SERVICE BULLETIN

from: TRIO-KENWOOD COMMUNICATIONS, INC.

SUBJECT: TS-180S DFC INSTABILITY

DATE 7/13/79

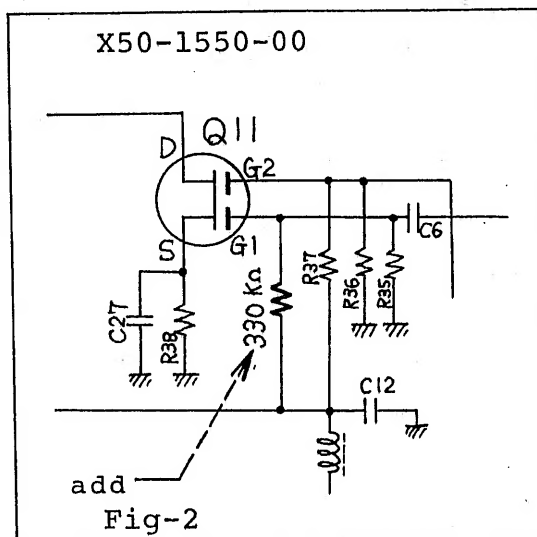
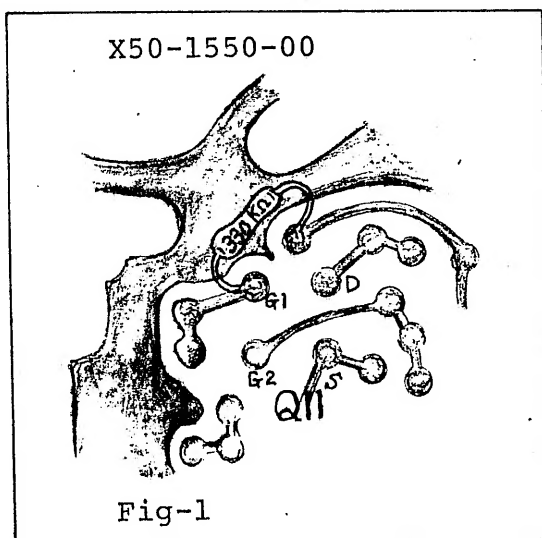
TS-180S operators may report intermittent DFC instability, especially at 10Khz even points. This may be characterized in some cases as FM'ing.

On the VCO unit X50-1550-00, install a 330K ohm resistor between Q11 G1, and the 8V line. Connect from L7 at C12 to Q11 G1, at R35.

No adjustments are necessary.
